DAWES SWITCHING STATION SUBDIVISION

APPLICATION NUMBER 7 DATE June 21, 2018

DETAIL SITE PLAN

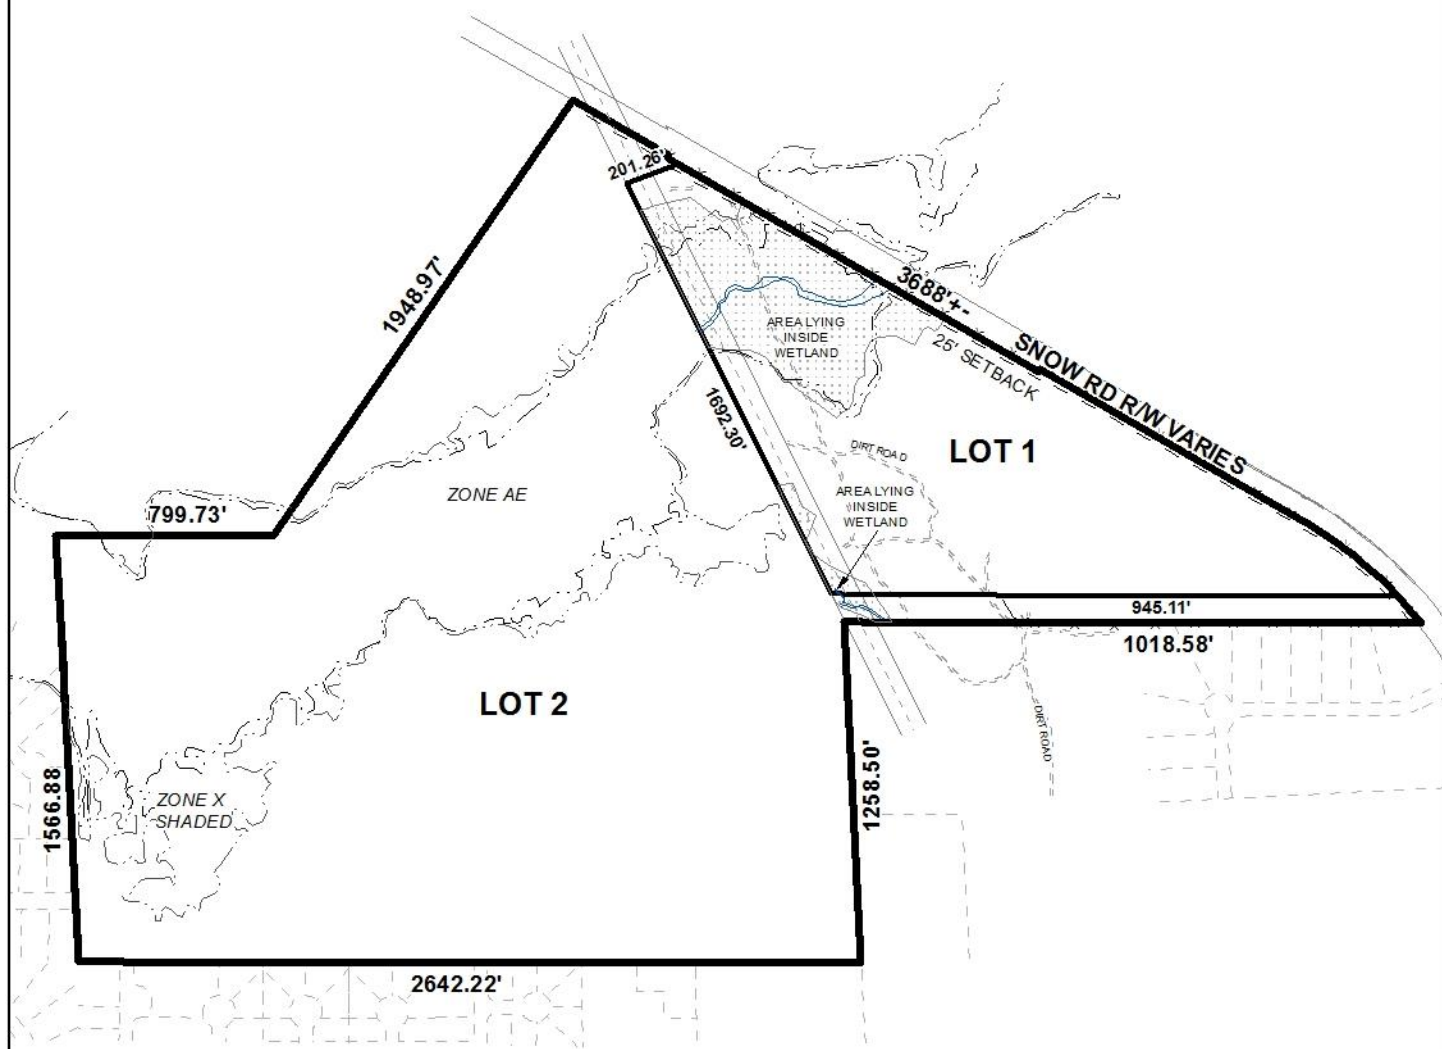
Both lots have frontage along Snow Road South, a major street requiring a 100' right-of-way width. Lot 2 is irregularly shaped and has two (2) frontages along Snow Road South: 403'± to the North of the site, and 144'± to the South of the site. Lot 2 also has frontage on Taylor Point Boulevard, Alderway Street, and Nadine Lane. Lot 1 also irregularly shaped, but has only one (1) frontage along Snow Road South. A varying right-of-way is illustrated on the preliminary plat, but previous subdivisions along Snow Road South required dedication. As such, revision of the plat illustrating dedication sufficient to provide at least 50' from the centerline of Snow Road South should be required, if approved.

Both frontages of Lot 2 on Snow Road are large enough to be potentially re-subdivided and, in accordance with Section V.D.3. of the Subdivision Regulations are not exclusive of unusable land, thus each frontage contributes to lot depths more than 3.5 times their widths at their potential building setbacks. Also, as mentioned, both lots are irregularly shaped with designs that are inconsistent with Section V.D.3. of the Subdivision Regulations. It should be noted, however, that the Planning Commission has approved other lots in the vicinity that also have irregular designs. As such, approval of the lots may be appropriate with a waiver of Section V.D.3. of the Subdivision Regulations.

Regarding access management, a note should be placed on the Final Plat, if approved, stating Lot 1 should be limited to three (3) curb cuts, and Lot 2 should be limited to two (2) curb cuts along its Northern Frontage, and one (1) curb cut along its Southern frontage, with any changes in their sizes, locations, or designs to be approved by Mobile County Engineering and conform to AASHTO standards. Lot 2 should be denied direct access to Taylor Point Boulevard, Alderway Street, and Nadine Lane.

Both lots satisfy the minimum size requirements of the Subdivision Regulations for lots without sanitary facilities, and are appropriately labeled in square feet and acres on the preliminary plat. This information should be retained on the Final Plat, if approved; or, provision of a table on the Final Plat providing the same information may suffice.

The 25' minimum building setback line along Snow Road South is illustrated, but not along Taylor Point Boulevard, Alderway Street, or Nadine Lane. If approved, the 25' minimum building setback line should be illustrated along all frontages, adjusted for any required dedication.

This site is located in the County; therefore, any lots that are developed commercially and adjoin residentially-developed property must provide a buffer in compliance with Section V.A.8. of the Subdivision Regulations. A note stating as much should be provided on the Final Plat, if approved.

Portions of both lots are located within the flood plain. As such, wetlands may occur on the site and may therefore be environmentally sensitive. Approval of applicable federal, state and local agencies may be required prior to development of the site.

A 100 foot wide Alabama Power easement crosses the site. A note should be placed on the Final Plat stating that only structures related to the easement may be placed within the easement.

- 1) revision of the plat to illustrate dedication sufficient to provide at least 50' from the centerline of Snow Road South;
- 2) placement of a note on the Final Plat stating Lot 1 should be limited to three (3) curb cuts, and Lot 2 should be limited to two (2) curb cuts along its Northern Frontage, and one (1) curb cut along its Southern frontage, with any changes in their sizes, locations, or designs to be approved by Mobile County Engineering and conform to AASHTO standards;
- 3) placement of a note stating that Lot 2 is denied direct access to Taylor Point Boulevard, Alderway Street, and Nadine Lane;

- 4) retention of the lot sizes in both square feet and acres on the Final Plat, or provision of a table on the Final Plat providing the same information;

- 5) depiction of the 25' minimum building setback line along all frontages;
- 6) placement of a note on the Final Plat stating that only structures related to the 100 foot Alabama Power easement may be placed within the easement;

- 7) placement of a note on the Final Plat stating any lots that are developed commercially and adjoin residentially-developed property must provide a buffer in compliance with Section V.A.8. of the Subdivision Regulations;

- 8) placement of a note on the Final Plat to comply with the Mobile County storm water and flood control ordinances: *"Must comply with the Mobile County Flood Damage Prevention Ordinance. Development shall be designed to comply with the storm water detention and drainage facility requirements of the City of Mobile storm water and flood control ordinances, and requiring submission of certification from a licensed engineer certifying that the design complies with the storm water detention and drainage facility requirements of the City of Mobile storm water and flood control ordinances prior to the issuance of any permits."*; and,
